Addendum No. 02

Memorial Stadium Modernization

Fieldhouse & Stadium

MADERA UNIFIED BID NO.: 073025
PBK PROJECT NO.: 20-51
DSA APPLICATION NO.: 02-121624 Fieldhouse
02-122784 Stadium

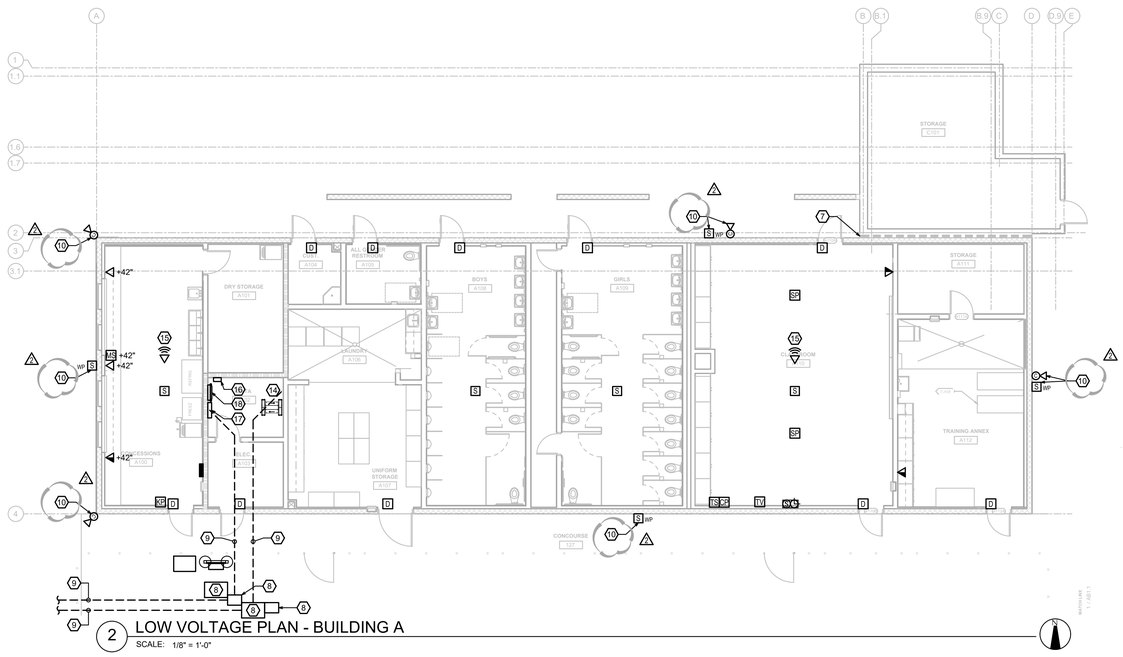
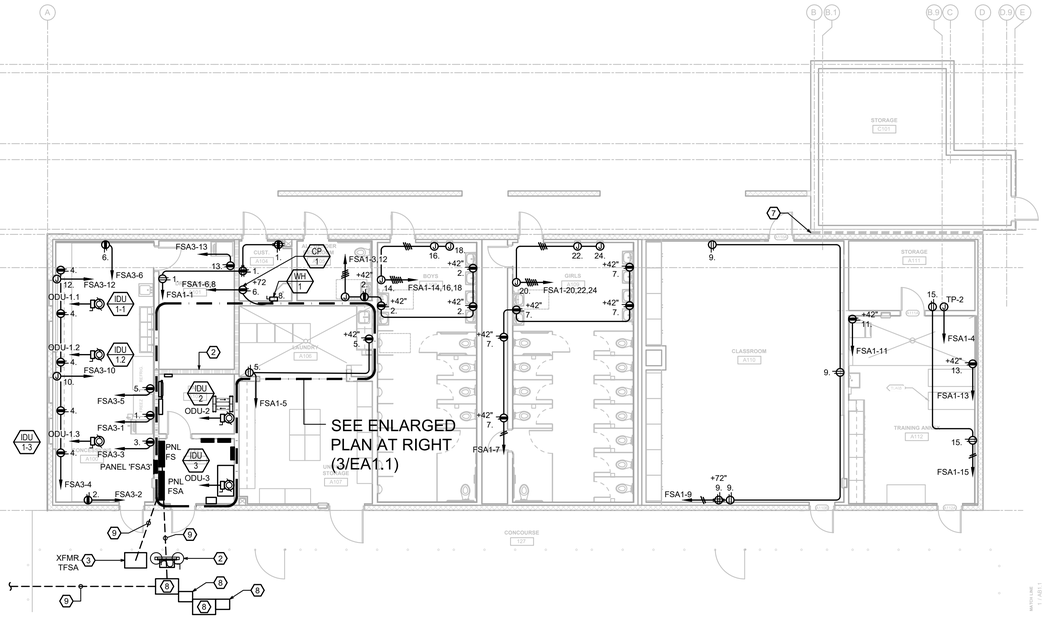
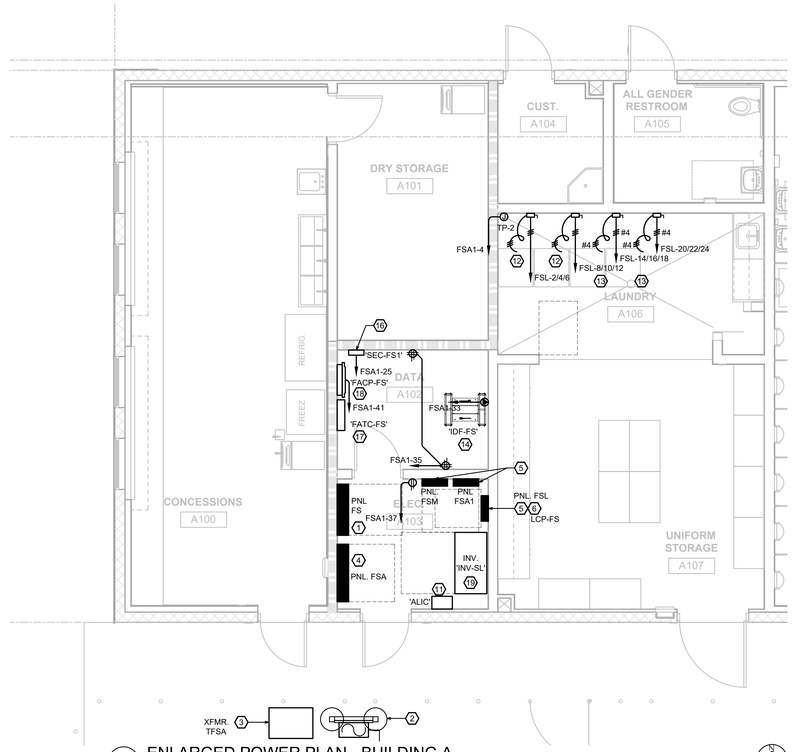
b. EA1.1 – POWER & LOW.VOLT. PLANS BUILDING A
- Corrected typo for boxes in block.

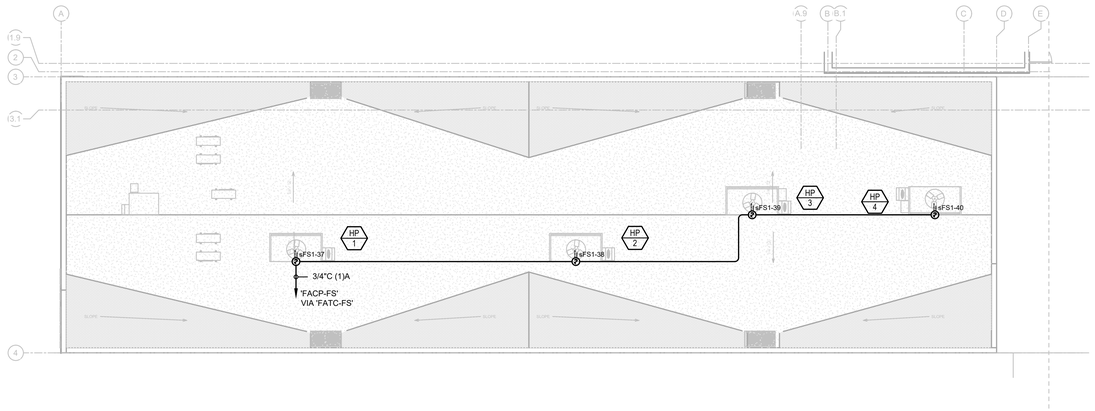
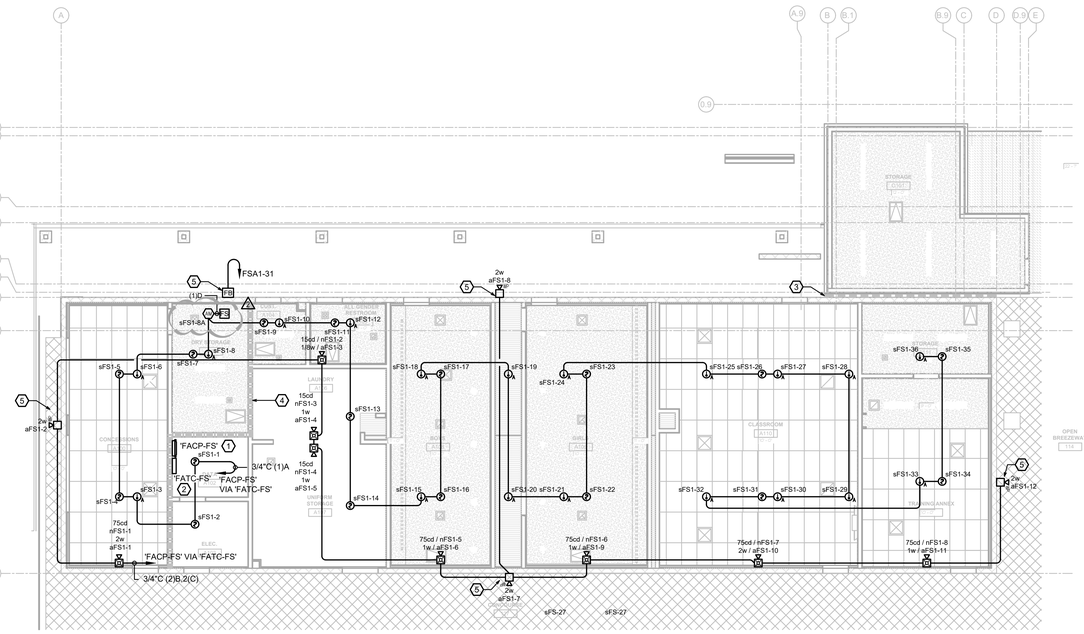
c. EA4.1 – FIRE ALARM PLAN BUILDING A
- Modified symbol for input module at riser.

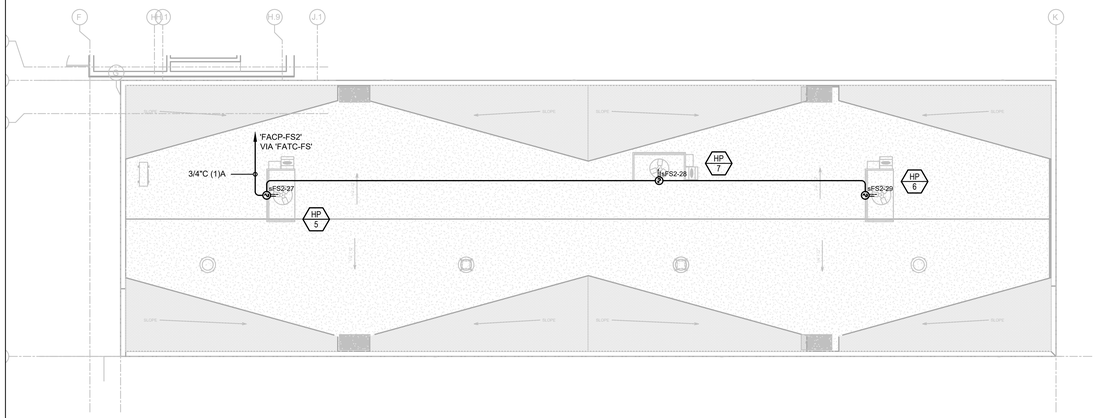
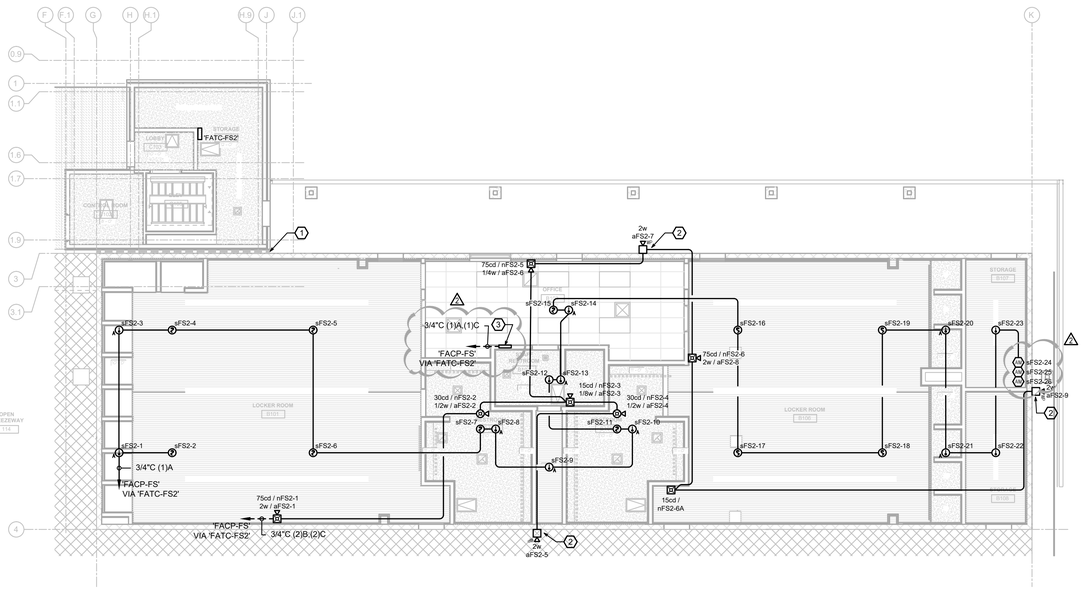
d. EB4.1 – FIRE ALARM PLAN BUILDING B
- Updated detail A10 for updated weight of larger fixture and changed name.
- Modified symbol for input module at riser.
- Added keynote 3.

G15 SINGLE LINE DIAGRAM

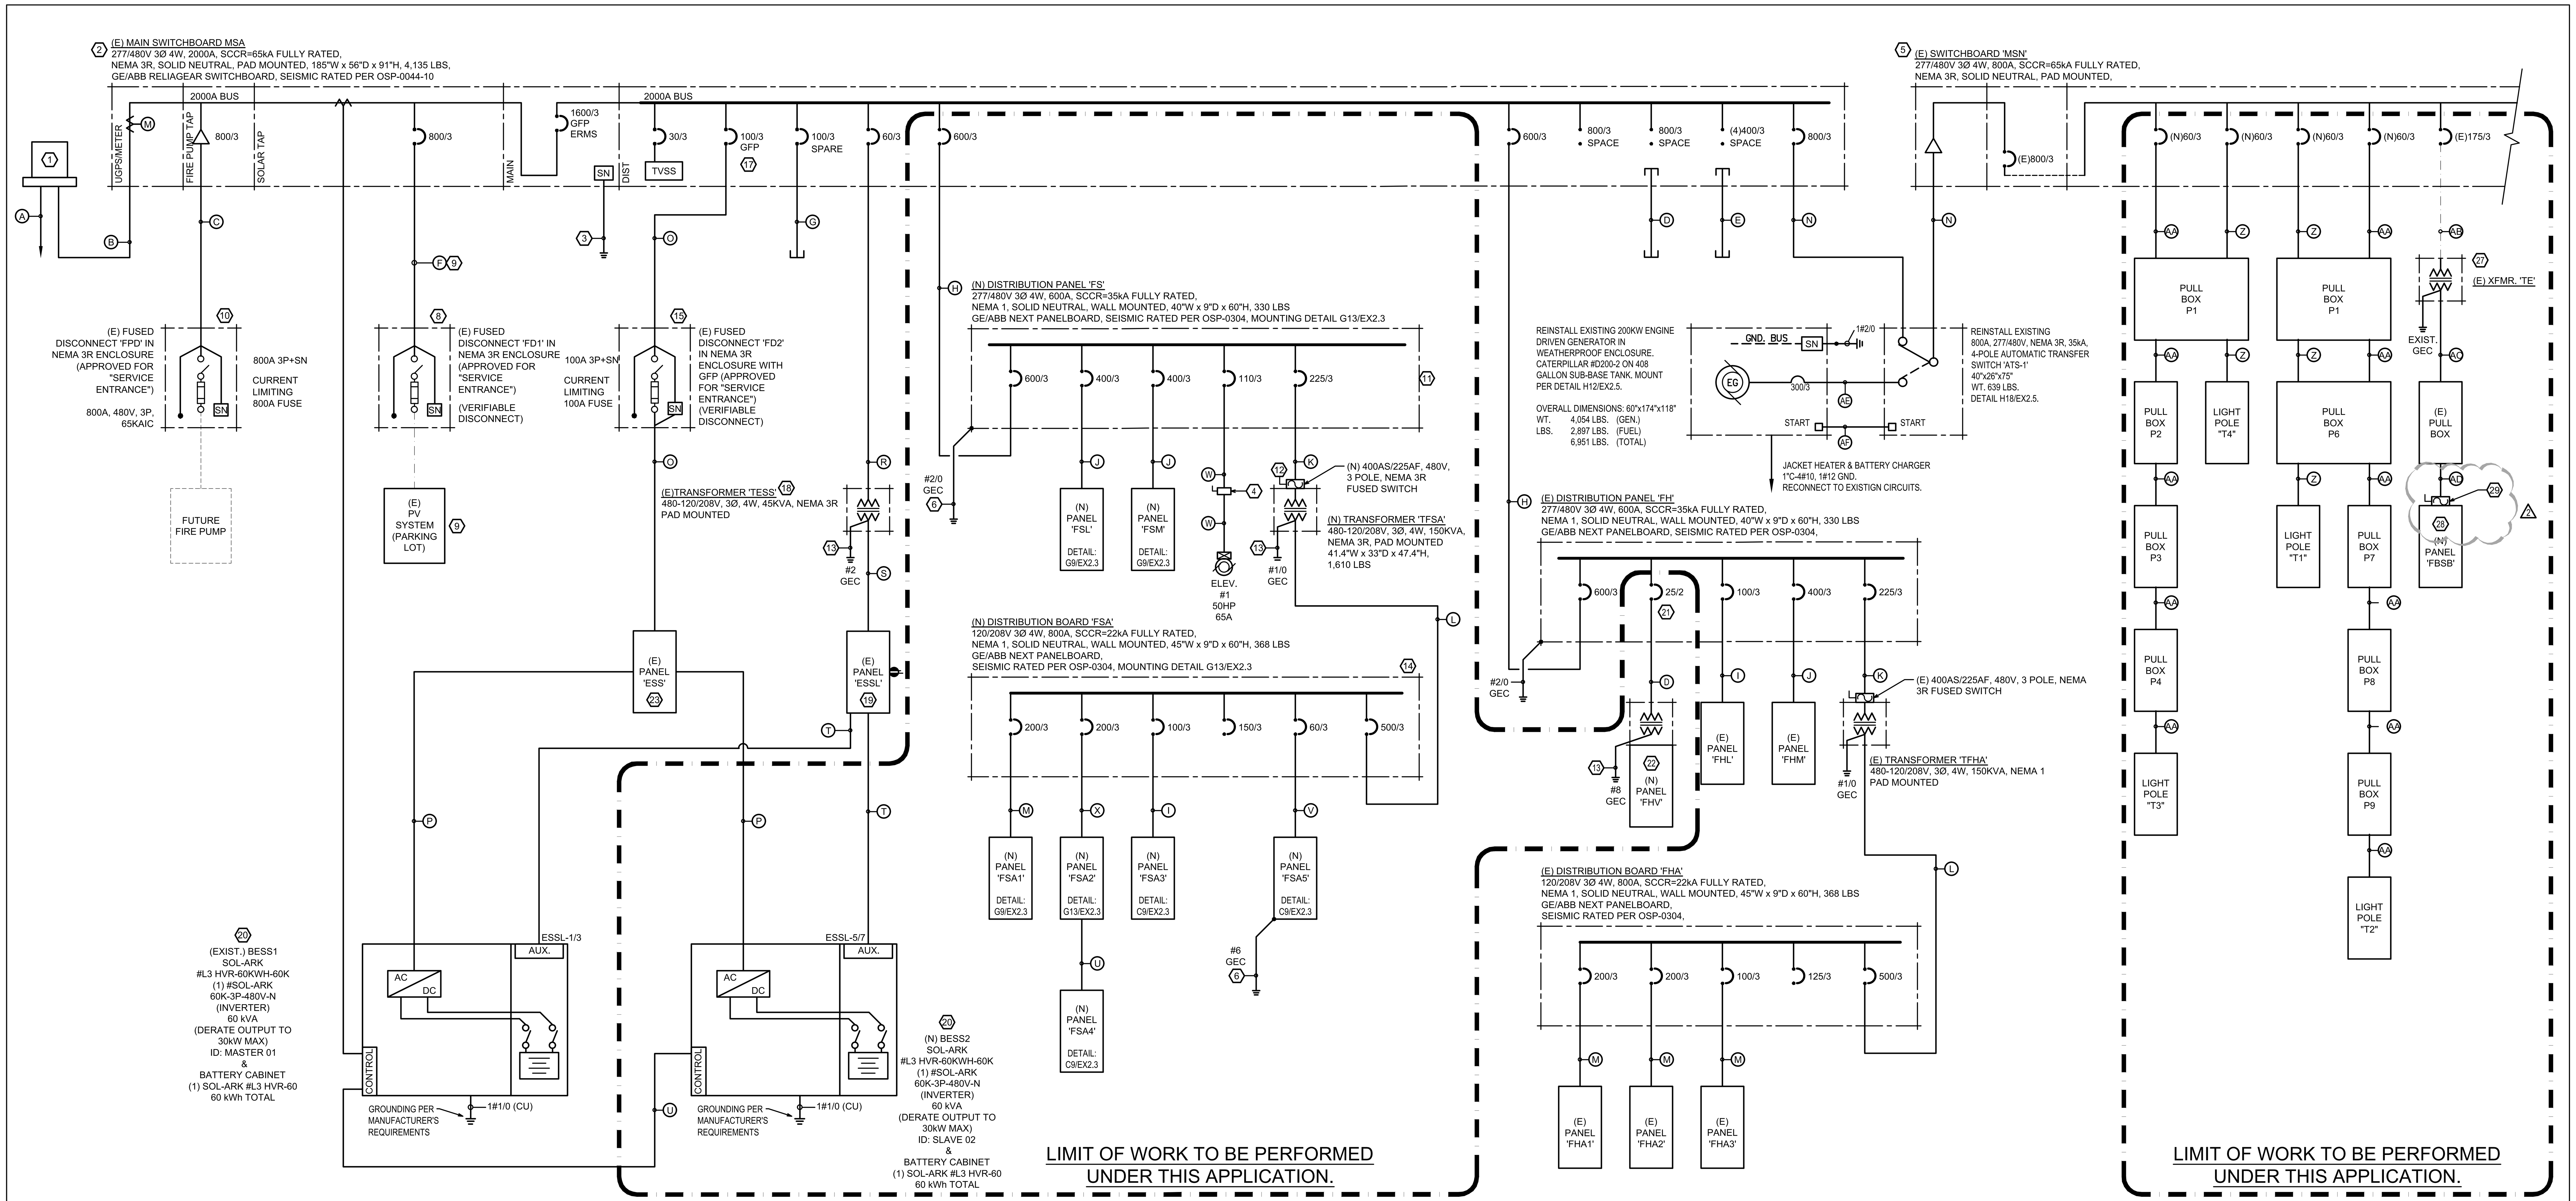
h. EX2.1 – ELECTRICAL SINGLE LINE DIAGRAM
- Added fused disconnect in front of panel 'FBSB'.
- Added keynote 29.
